Various DNR Properties – ADA Compliant Playground Improvements
IDOA Project #E010-017A

Addendum #3 – January 3, 2018

REA Project #:	161448
Date:	11/28/2017
Drawn by:	KK
Reviewed by:	CK
DRAWING #:	SD210

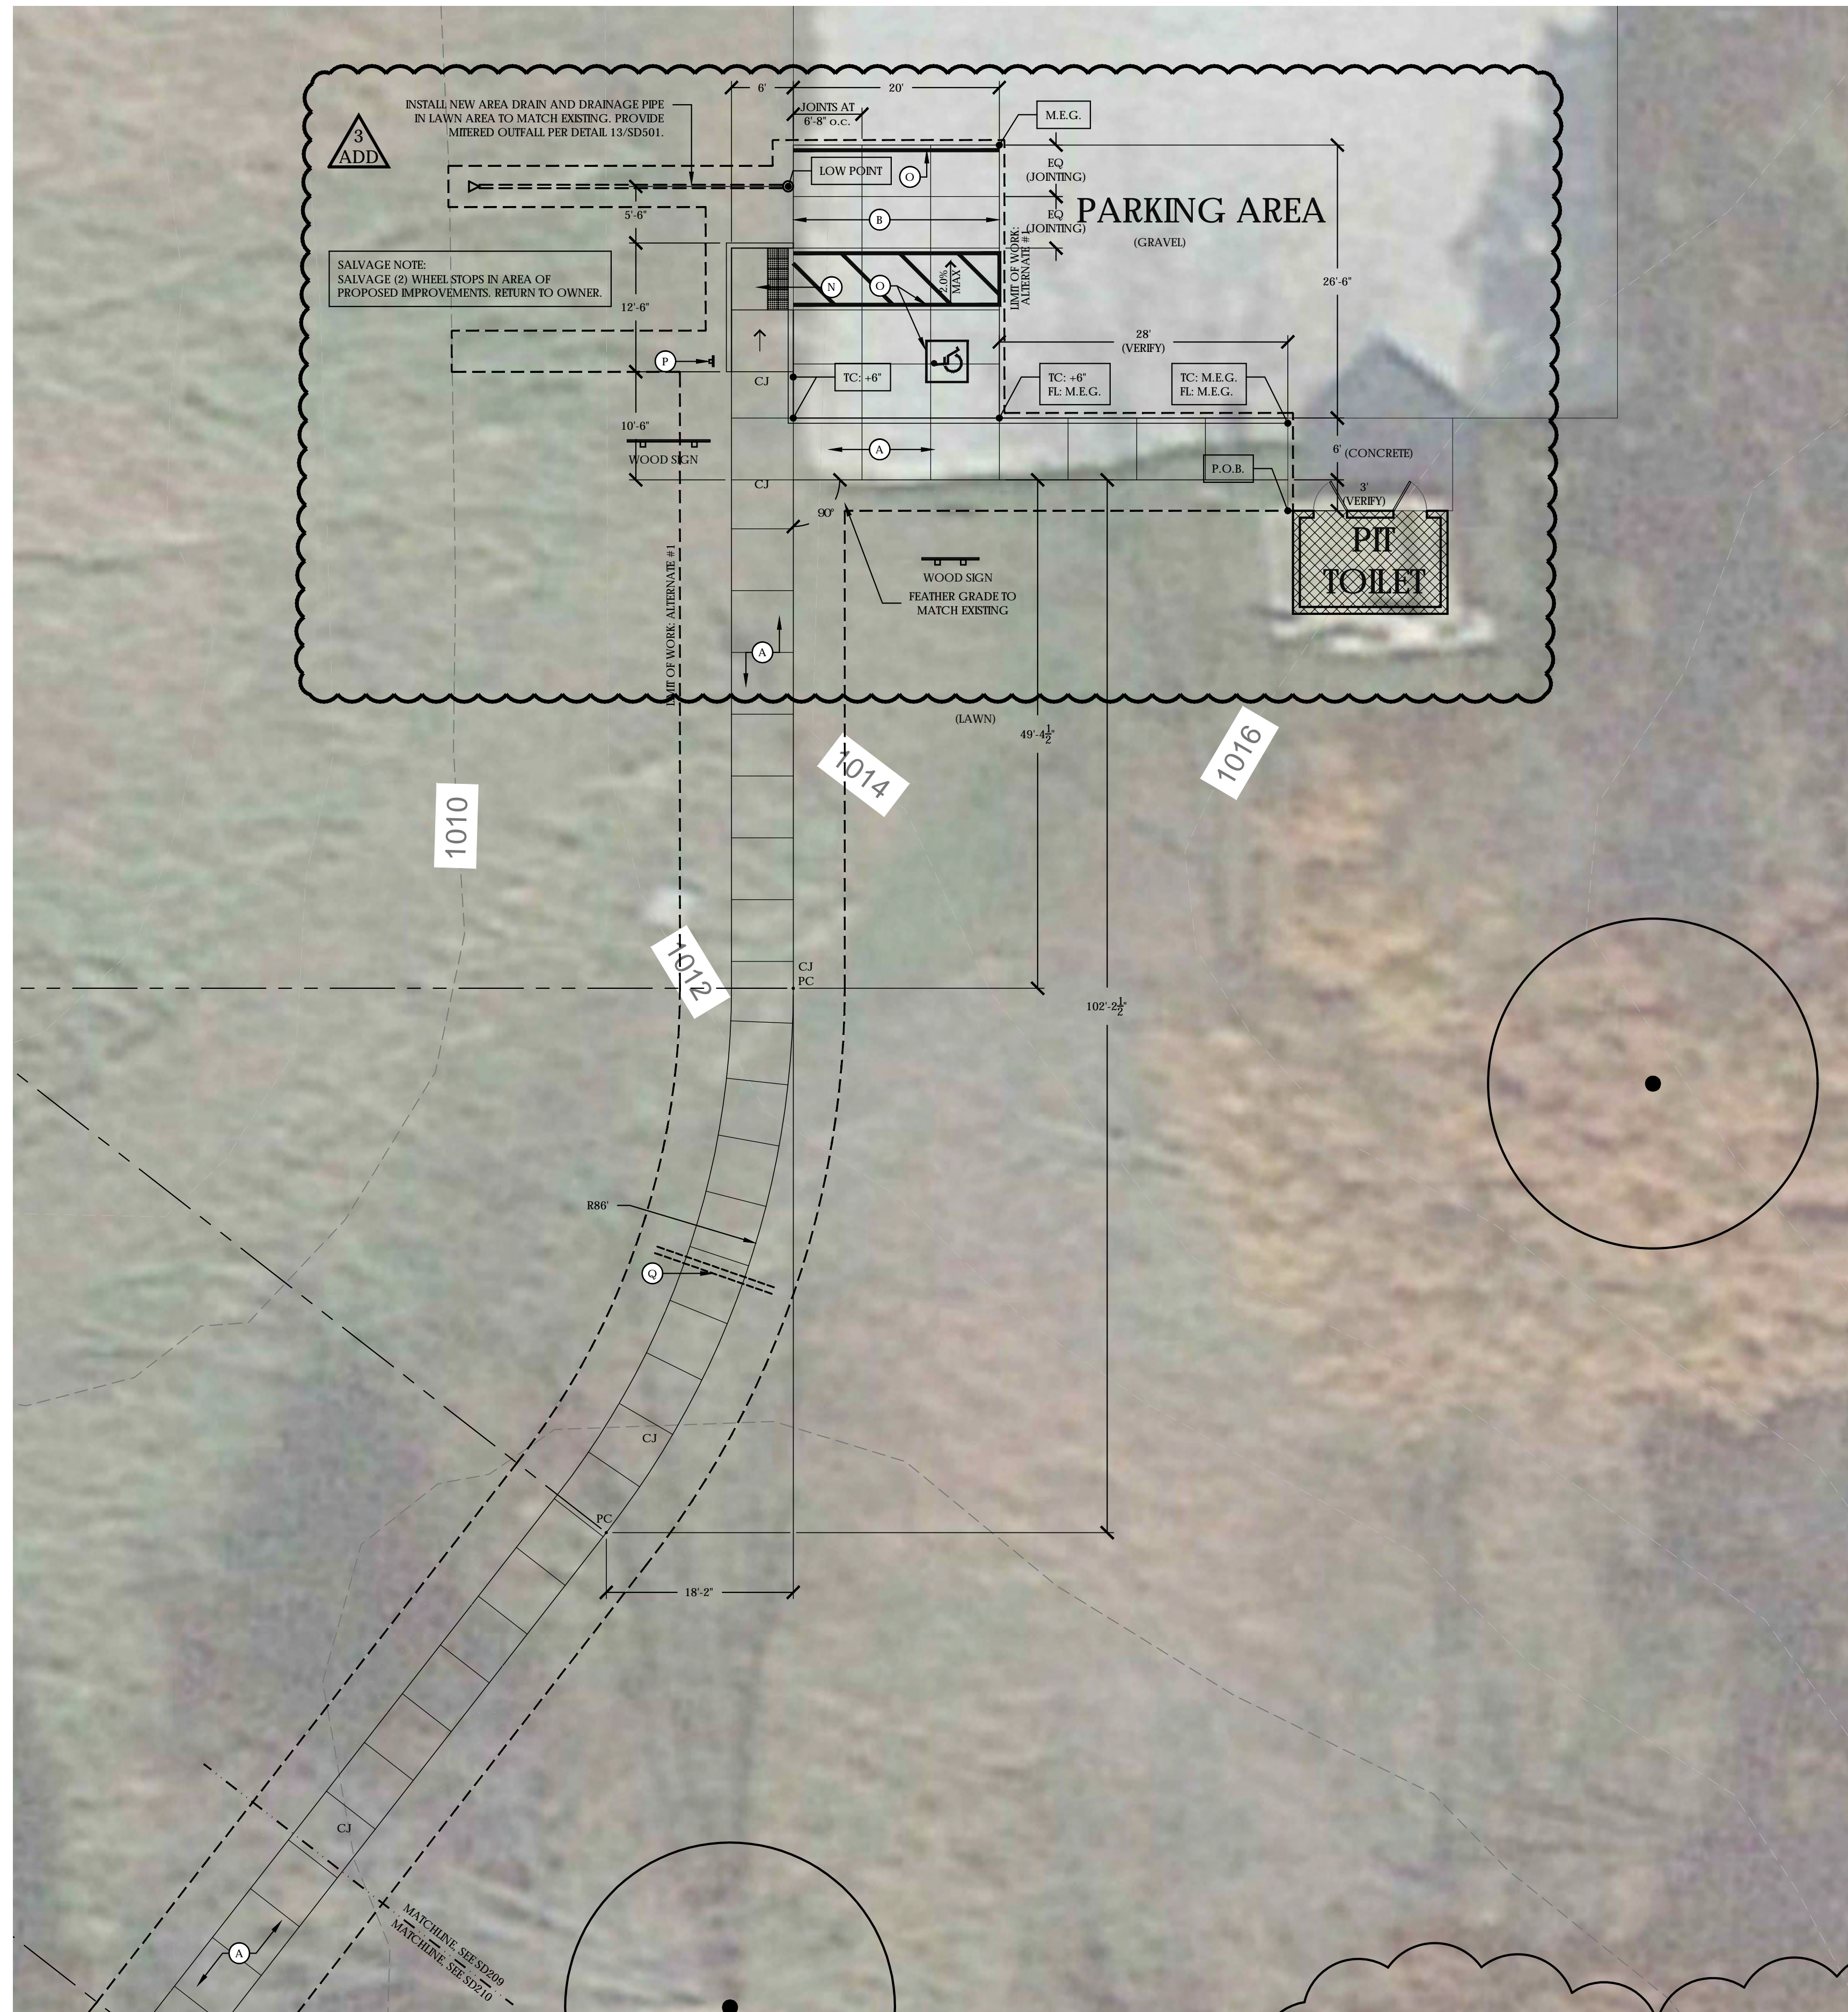
QUESTION #12: *There is an existing catch basin and storm drain in conflict with the design shown for the parking at Trine State Recreation Area. Will resolution of that conflict be the responsibility of the Contractor?*

- ITEM #4:** REPLACE Sheet SD210 with the attached. Update parking lot layout as part of Alternate #1.

ANSWER #12: See Revision to Drawings, sheet SD210. The existing catch basin shall remain in place. Contractor shall protect basin from damage during extent of Work. Contractor shall provide erosion/sediment control measures per the specifications.

2 POKAGON PLAYGROUND - LONGITUDINAL SECTION
 SCALE: 1/4" = 1'-0"

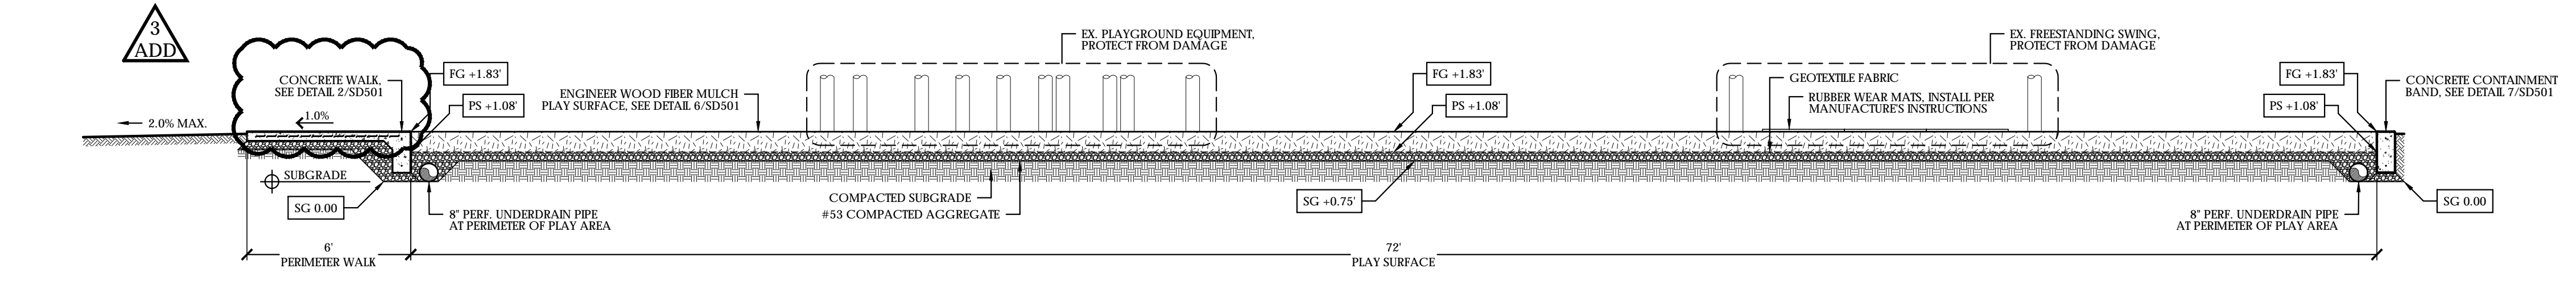
- ITEM #5:** REVISE details 2 & 6/SD302. Maintain existing containment band as indicated.

3 PATOKA LAKE PLAYGROUND - LONGITUDINAL SECTION
 SCALE: 1/4" = 1'-0"

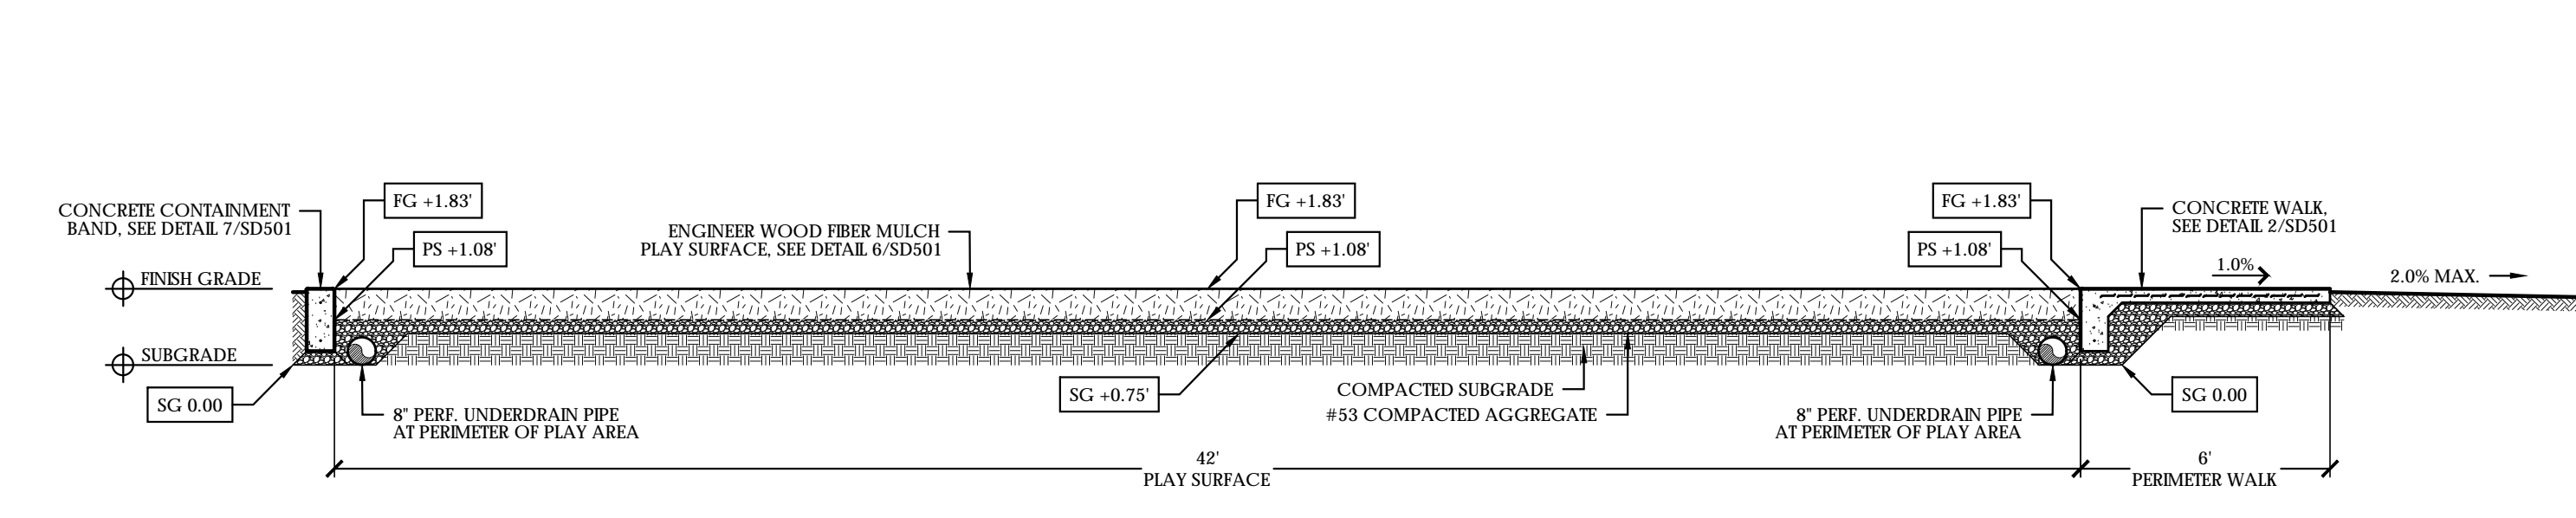
- ITEM #6:** REVISE detail 3/SD302 to reference concrete perimeter walk as detail 2/SD501.

2 PARKING LAYOUT ENLARGEMENT [ALTERNATE #1, 3, & 5]
SCALE: 1/4" = 1'-0"
DIMENSIONS ARE TYPICAL UNLESS OTHERWISE NOTED ON PLANS

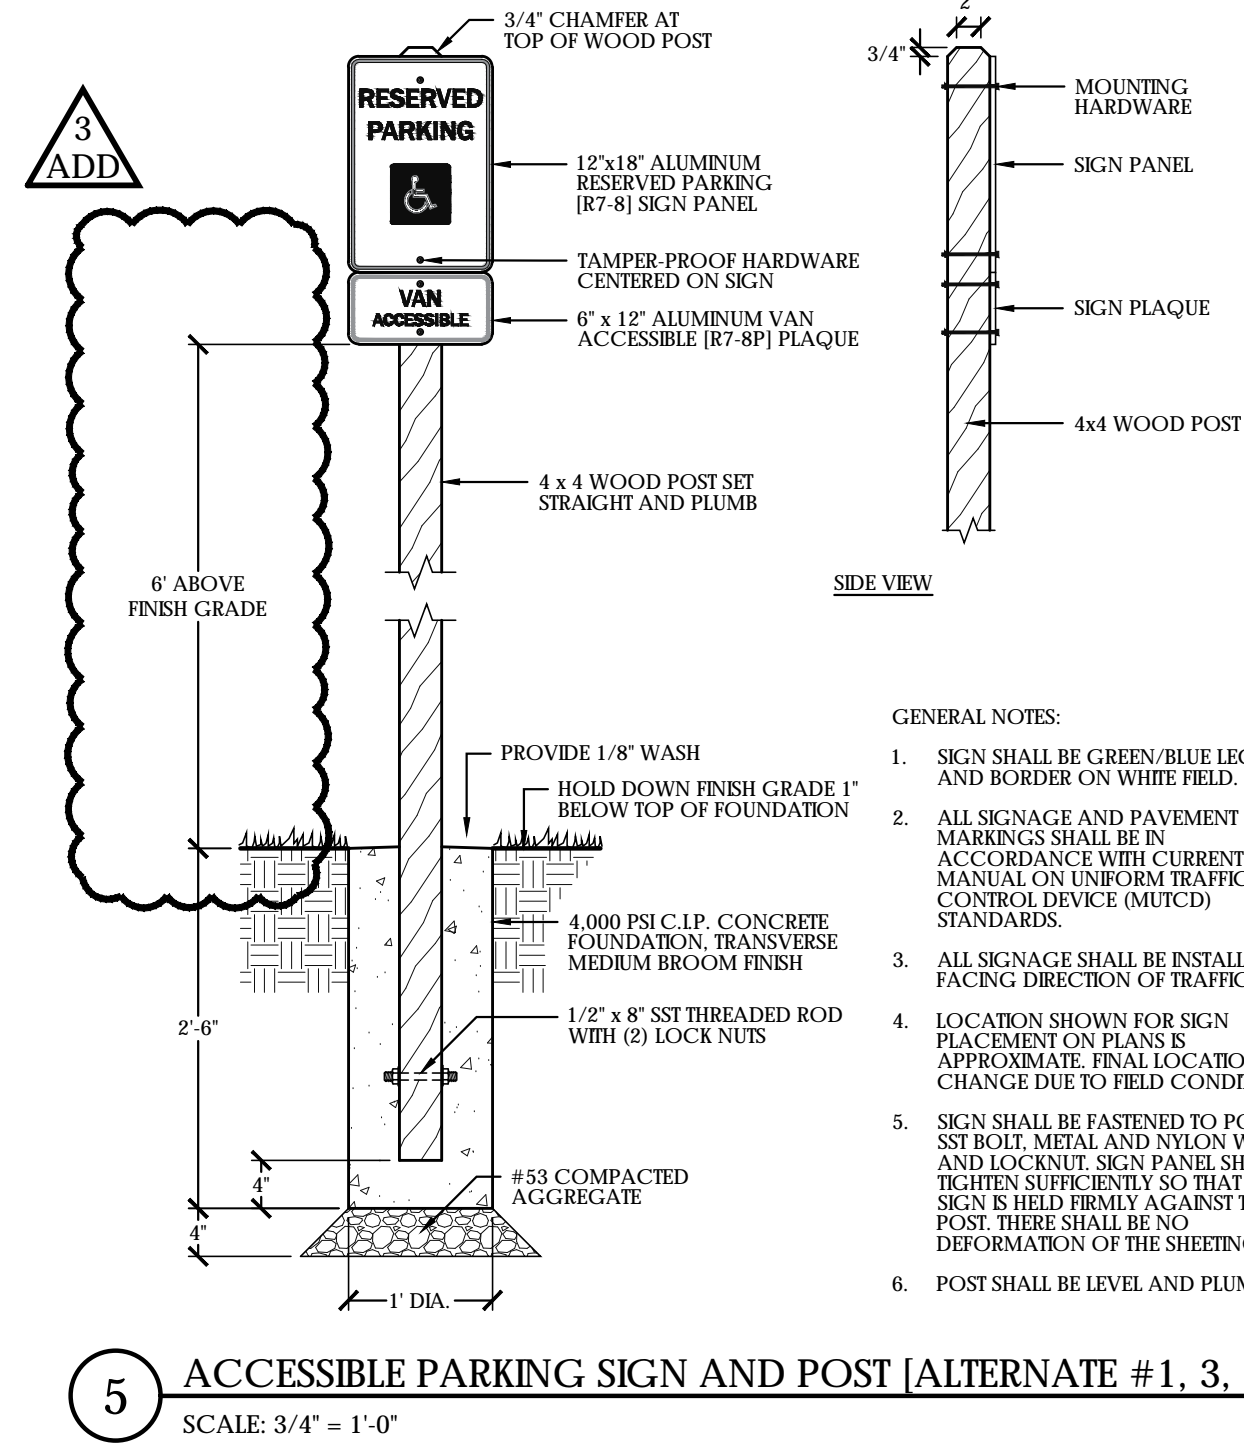
ITEM #7: REVISE detail 2/SD502. Adjust layout of ADA parking space.

5 ACCESSIBLE PARKING SIGN AND POST [ALTERNATE #1, 3, & 5]
SCALE: 3/4" = 1'-0"

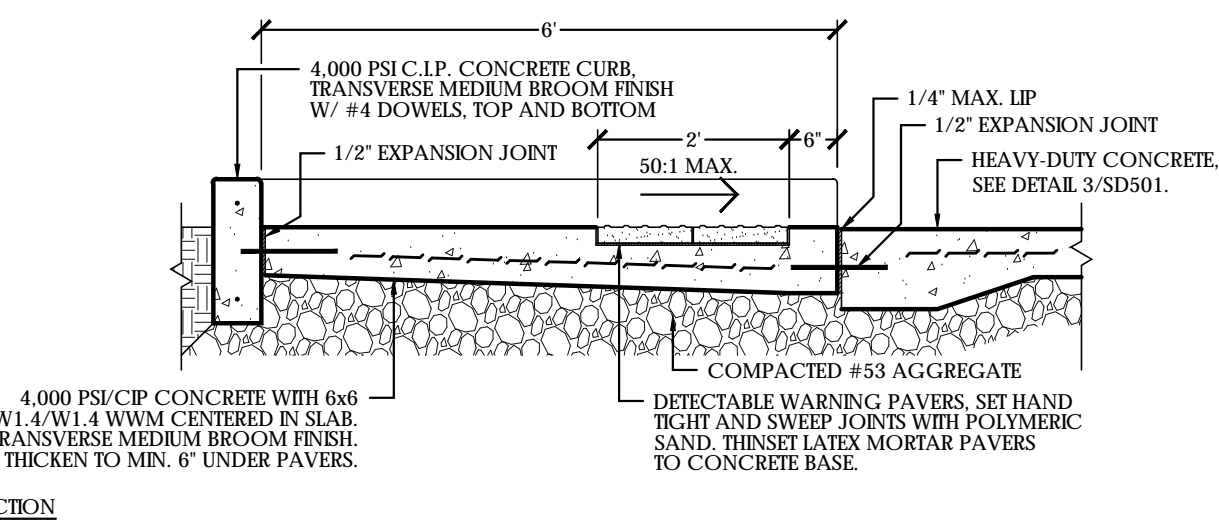
ITEM #8: REVISE detail 5/SD502. Adjust mounting height of sign panel.

6 DRY WELL DETAIL
 SCALE: 1/4" = 1'-0"

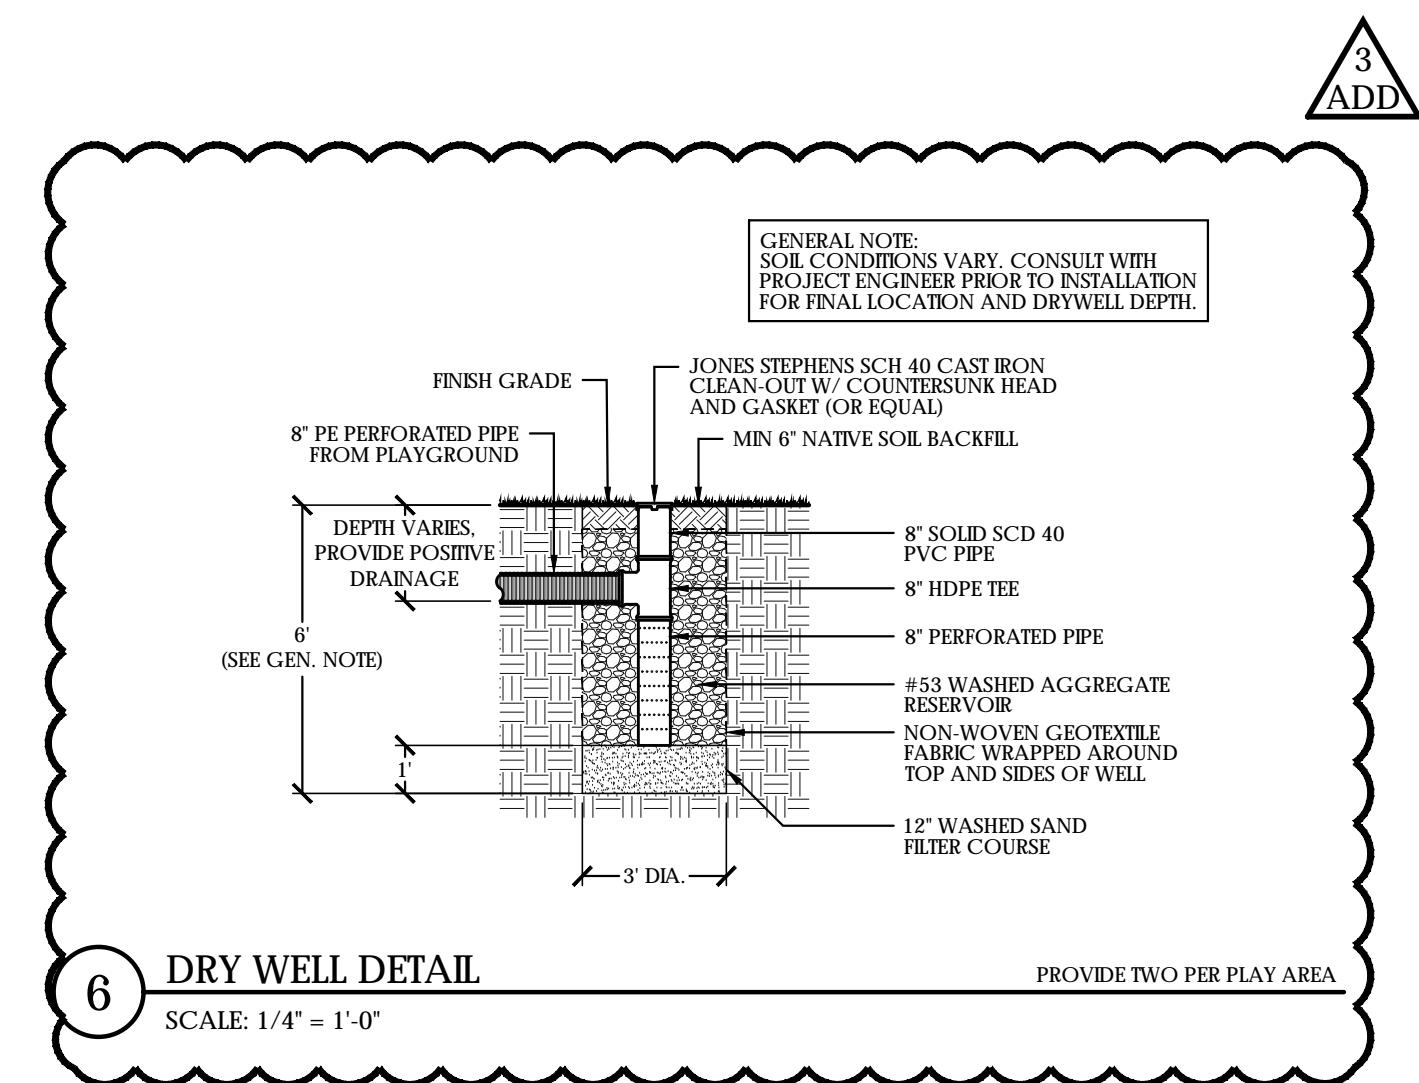
QUESTION #2: *Detail 6/C504 shows a 5' diameter by 12' deep dry-well. In general, to provide that design would require a set of equipment that would likely be mobilized for the other work. In addition, we have observed rock in the vicinity of several of the project sites that may limit the depth of excavation. Can the design change to accommodate these conditions?*

ITEM #9: REVISE detail 6/C504. Adjust dimensioning of dry-well.

ANSWER #2: See revised detail 6/C504. Consult with Project Engineer prior to installation for final location and drywell depth.
